**From:** Steve Yang <SYang@soraa.com>  
**Sent:** Friday, September 04, 2015 5:12 PM  
**To:** lighting@energystar.gov  
**Subject:** Energy Star Lamps V2.0 Draft 3 Comments

Thank you for the opportunity to provide feedback/comments for Lamp V2.0 draft 3 specification. Below are the comments from Soraa Inc.

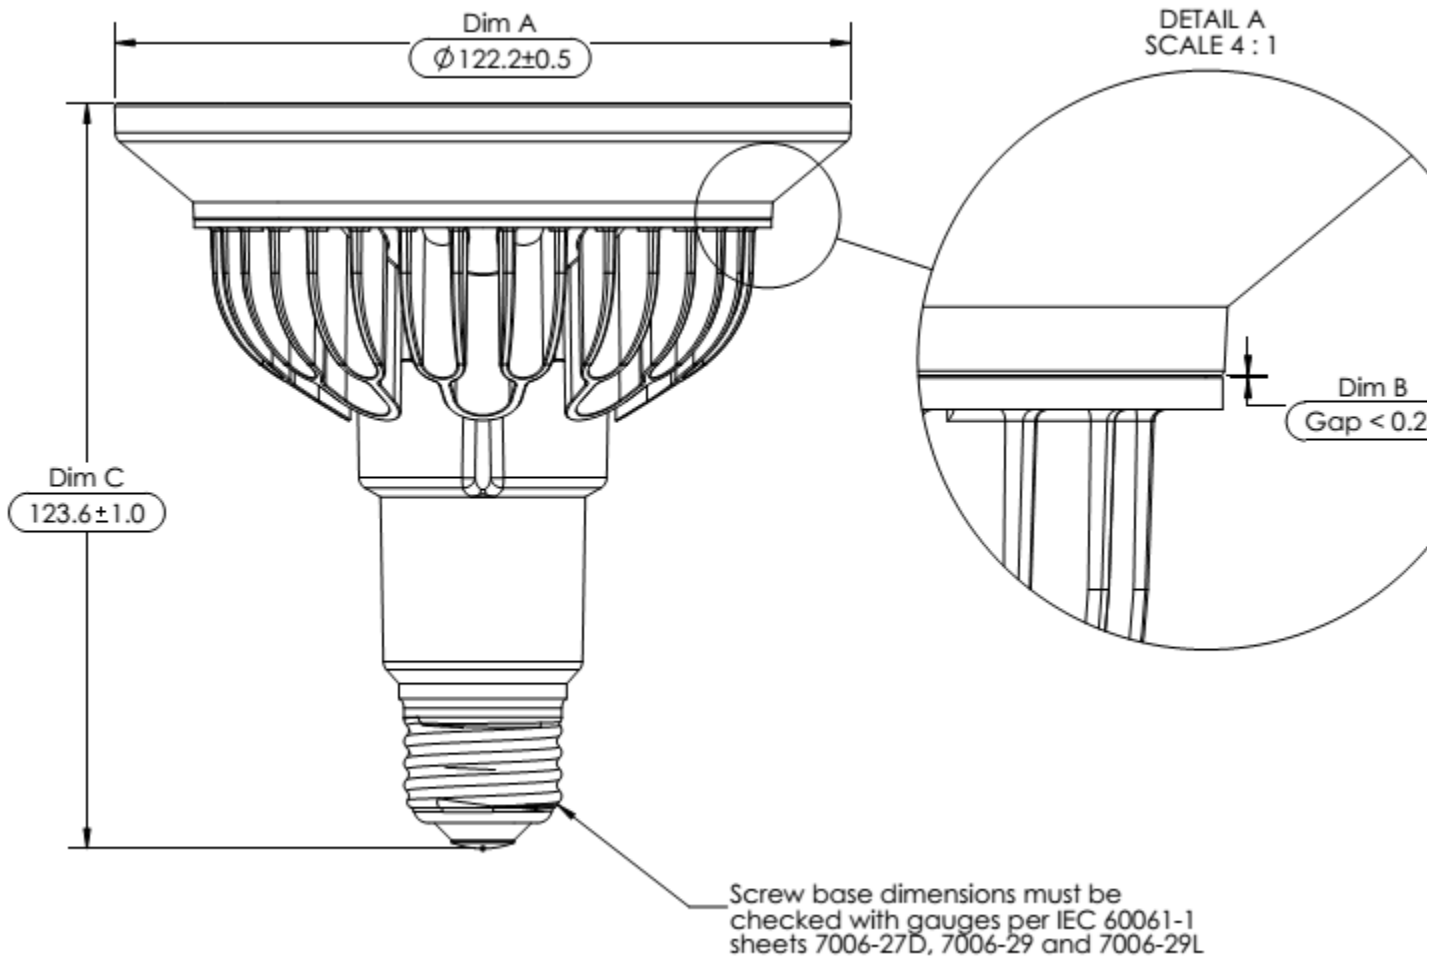
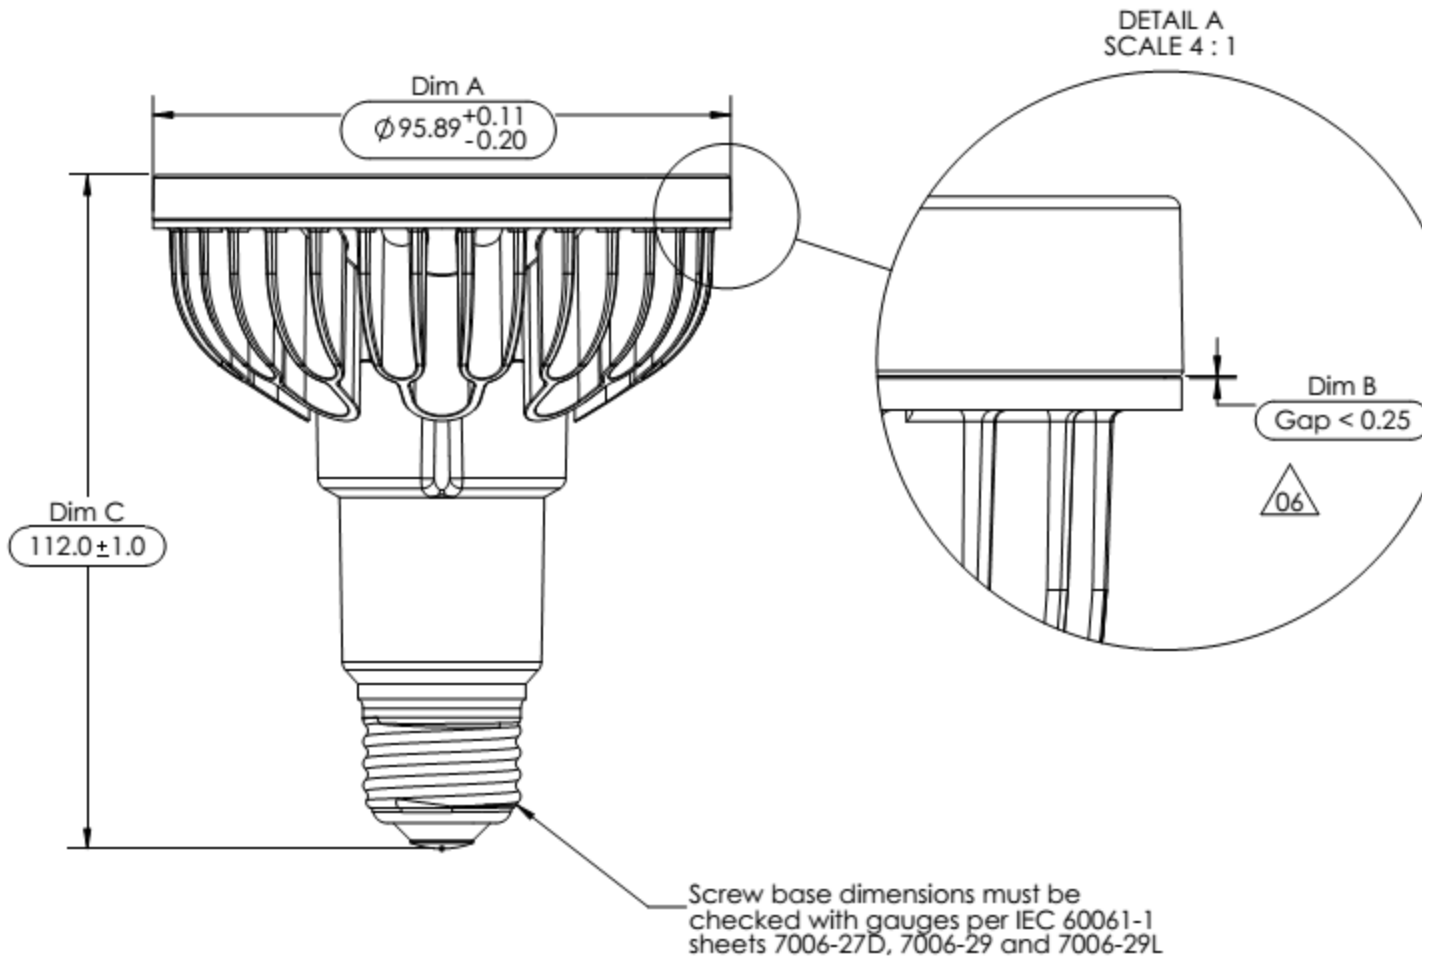
One of the variations we like to add to this list is “trim” accessories used for LED lamps. We designed a “trim” accessory for our PAR30L lamp and the trim is an accessory to the lamp. This has no impact with the performance of the lamp. Additional data can be collected to verify there are no negative thermal impact on the LC and other critical parts of the lamp.

The only component change is with “a trim” or without one.

The lamp is built on the same platform as our PAR30L which is being tested and to be certified by Energy Star. Given this precedence, the PAR30L with a trim accessory should be accepted as the same family as PAR30.
